TOWN OF FAIRFAX STAFF REPORT

TO: Fairfax Planning Commission
DATE: January 11, 2024
FROM: Linda Neal, Principal Planner
LOCATION: 79 Wood Lane; APN # 002-062-03
ZONING: RS-6, Single-family Residential Single-family Zone
APPROVED PROJECT:
New single-family residence, detached garage/accessory dwelling unit (ADU)
PROJECT UNDER CONSTRUCTION:
Single-family residence with a junior accessory dwelling unit (JADU) on the second floor, an accessory dwelling unit (ADU) in the basement and a detached garage
ACTION: Project review for compliance with Resolution No. 2022-01, A Resolution of the Fairfax Planning Commission Conditionally Approving Application No. 21-17 for a Hill Area Residential Development Permit, Design Review Permit, Excavation Permit, Tree Removal Permit, and Combined Side-yard Setback and Retaining Wall Height Variance for a Residence at 79 Wood Lane.
APPLICANT: Coby Friedman
OWNER: Same as above
CEQA STATUS: Categorically exempt, § 15303(a) and (e).

79 WOOD LANE

2 PROPOSED BASEMENT FLOOR PLAN
A2.1 SCALE: 1/4" = 1'-0"

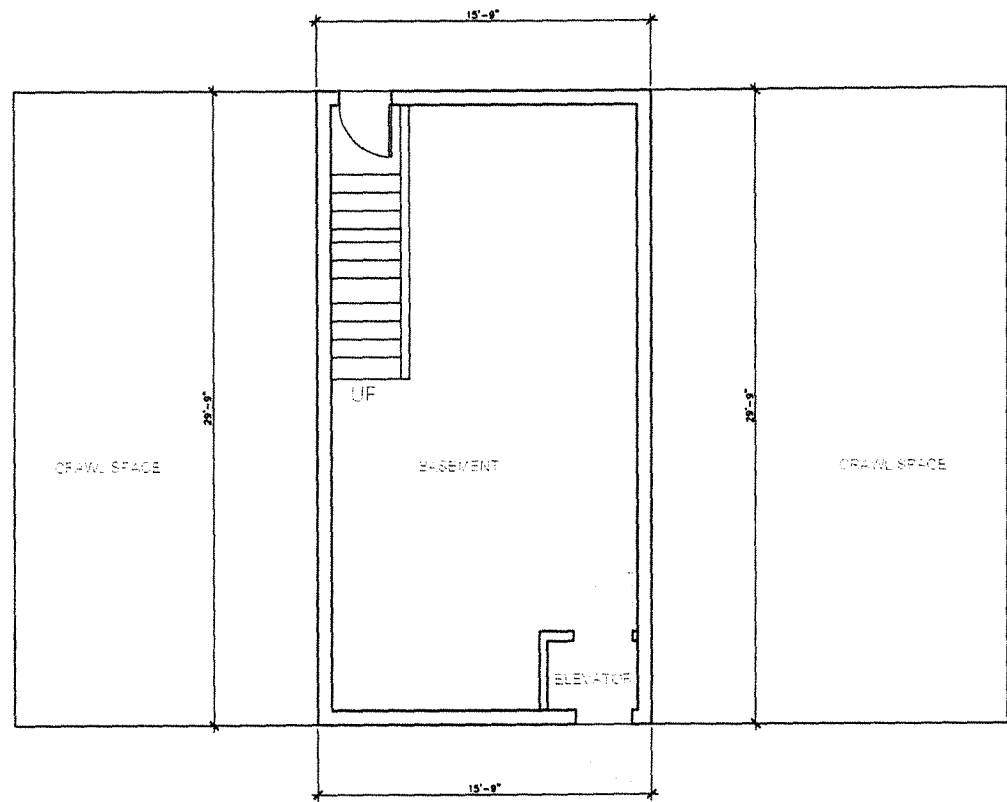
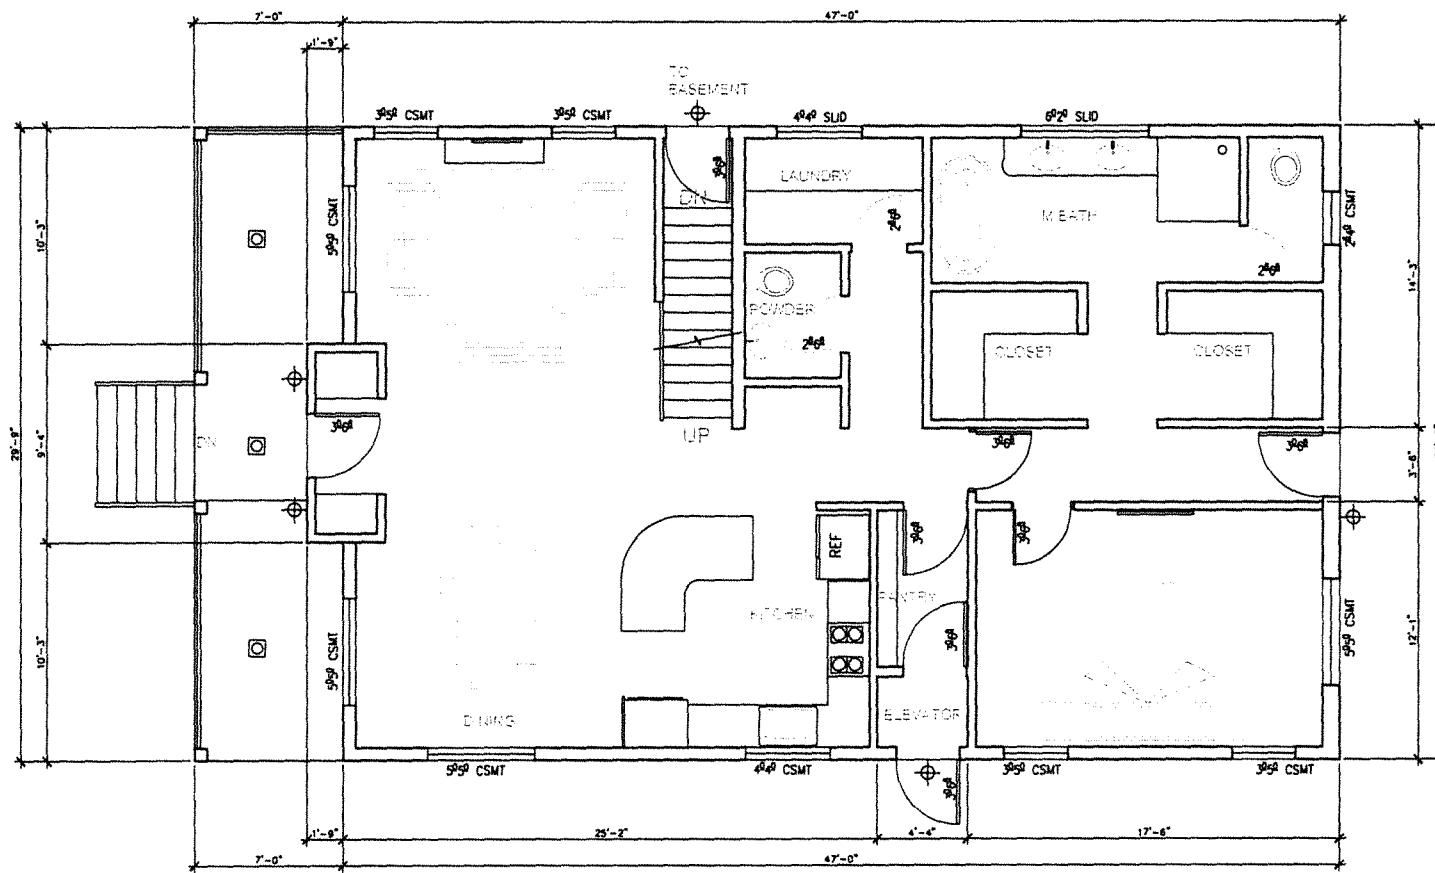
The building permit for the project was issued on August 4, 2022. Shortly after the permit was issued the Building Official discovered that the basement, which was supposed to have only 469 square-feet of basement area with 6-foot ceilings while the rest of the under-floor area was to be crawl space with overhead clearance of around eighteen inches, was excavated so that the entire underfloor area was excavated to the same depth (See original plan set page A4.1). The Building Department posted a red tag and stopped the project construction. The applicant's attorney filed an ex parte application on August 29, 2022 seeking a lifting of the Order to Stop Work. Through negotiations, the applicant agreed to work with the Building Official to reach agreement regarding the basement.

The applicant subsequently modified the subfloor so that the east and west sides of the subfloor areas have slightly higher finished elevations than the center portion of the basement but not high enough to comply with the Planning Commission approved project plans for the basement (Attachment B - see the building sections on page A4 of the approved plan set). No information was provided to the Department of Planning and Building Services on whether the change in the excavated basement area changed the excavation and fill amount approved by the Planning Commission on January 20, 2022, which was for the excavation of 130 cubic yards of material and the fill of 125 cubic yards of material. Work was allowed to resume by the Building Official when areas of the underfloor that were supposed to be crawlspaces were partially filled though not to the extent in the plans approved by the Planning Commission (Attachment B - page A4).

GROUND FLOOR PLAN

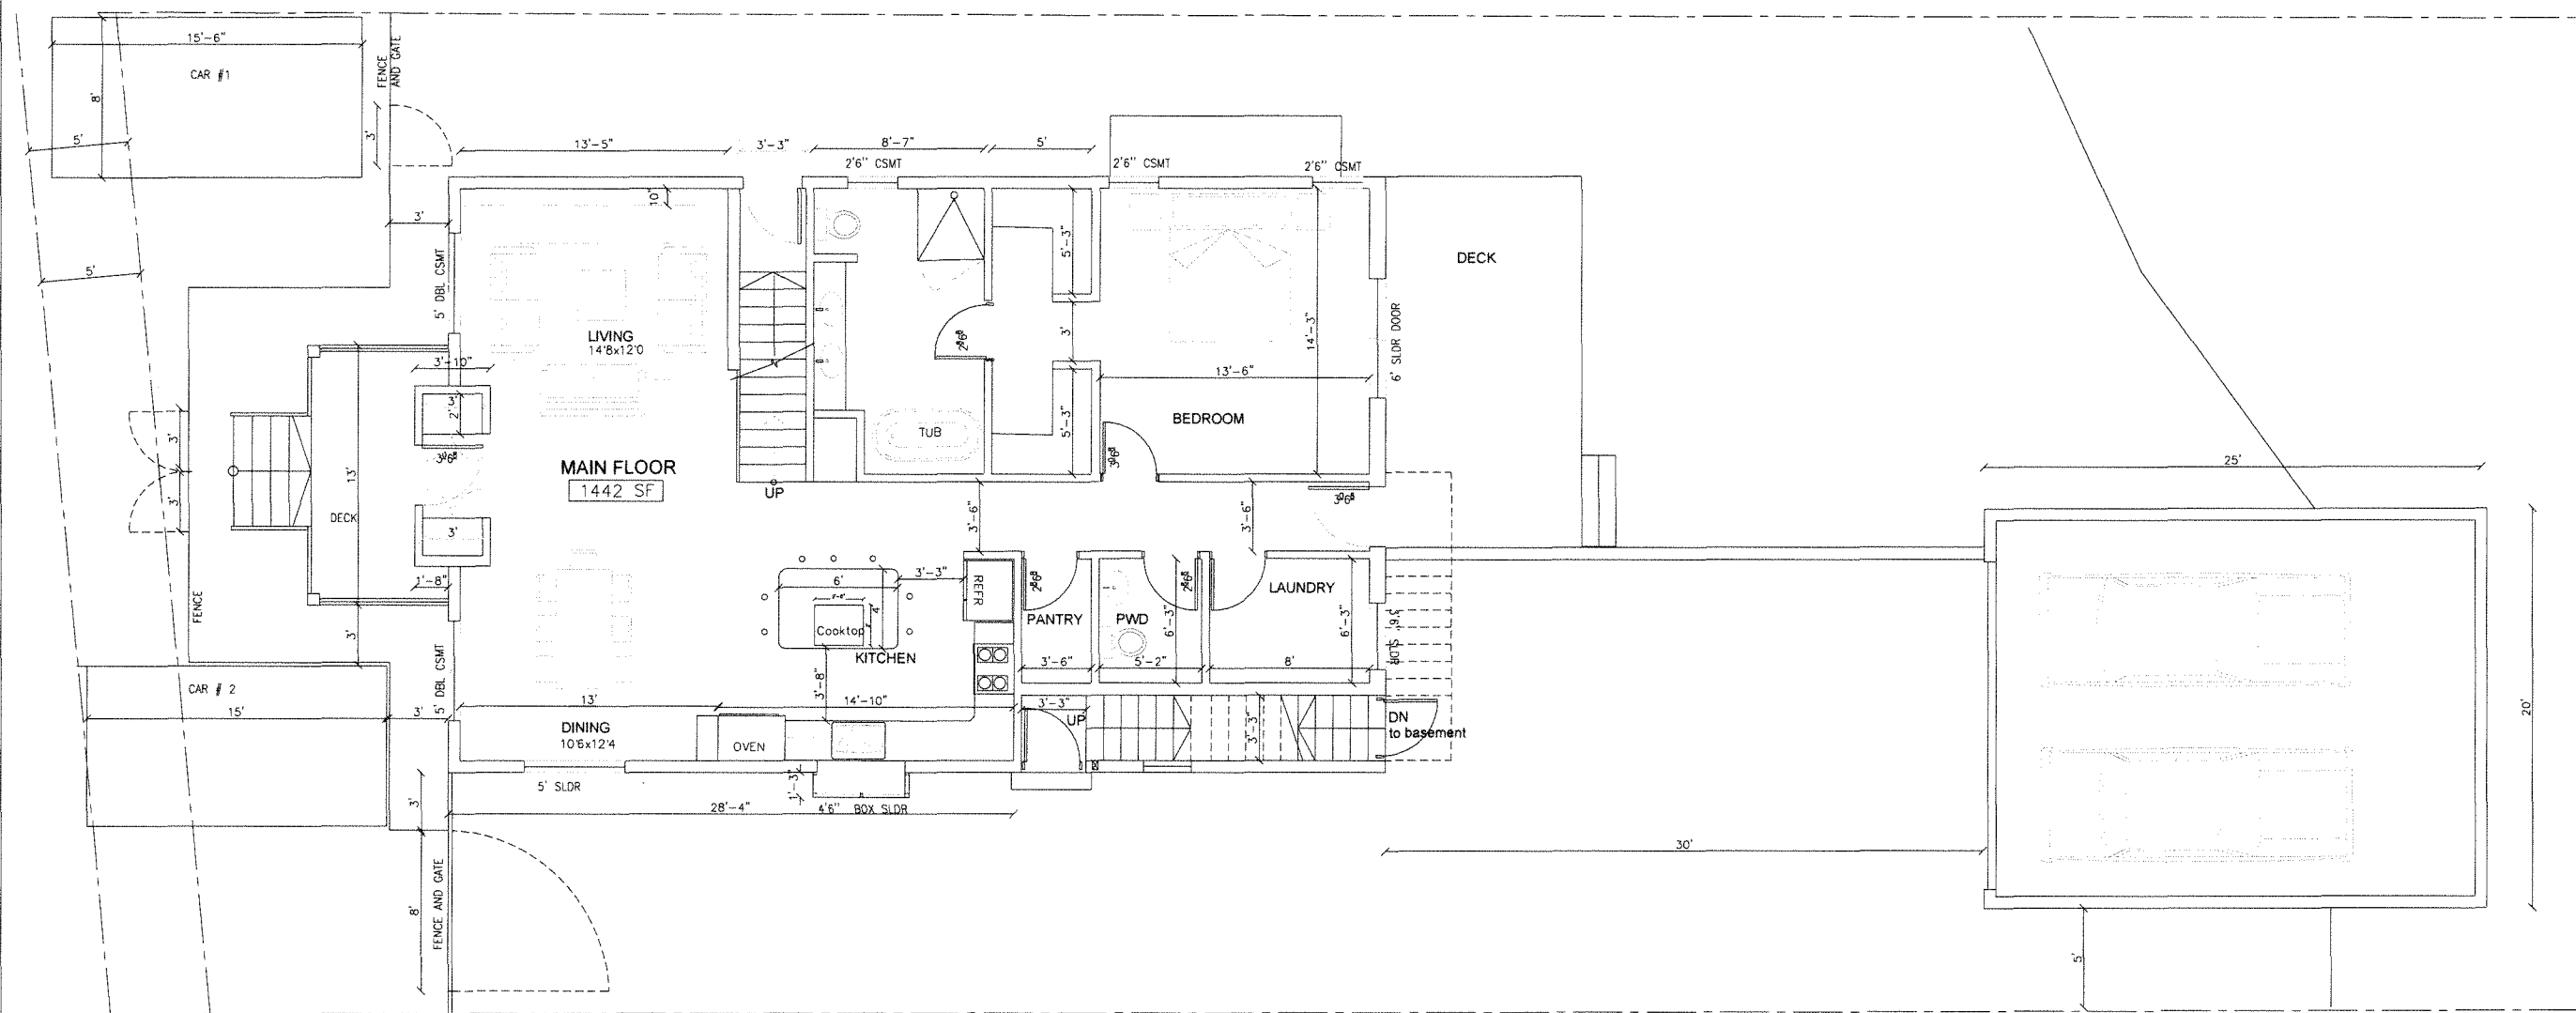
4. The 400 square-foot, two car garage/ADU structure has been eliminated. The revised plans show a two-car garage located 10-feet further south than the

approved garage site, maintaining a 30-foot setback from the house. However, measurements of the garage foundation in the field by staff revealed the structure foundation is only 14-feet in width and can accommodate only one parking space with some extra width possibly for storage so the foundation that has been constructed on the site does not match the location or size of the garage on the submitted revised plan set.

12. The window at the rear southeast corner of the first floor has been replaced with a sliding glass door to a rear ground level deck.
13. The ground floor of the west side of the structure was approved for four windows but the revised plans provided to the Building Official propose only three windows.

14. The approved plans for the upper floor of the west side of the building showed two windows and the revised plans provided to the Building Official now propose four windows.
15. Two clerestory windows have been added to the basement floor on the west side of the structure.
16. The window over the kitchen sink has been replaced with a bay window in the revised plans provided to the Building Official.
17. The approved Landscape plan, approved project plans set page A1, has two trees shown to be maintained in the area with the revised plan set provided to the Building Official shows a second driveway/parking space (Attachment C - unnumbered first page of the revisions plan set).
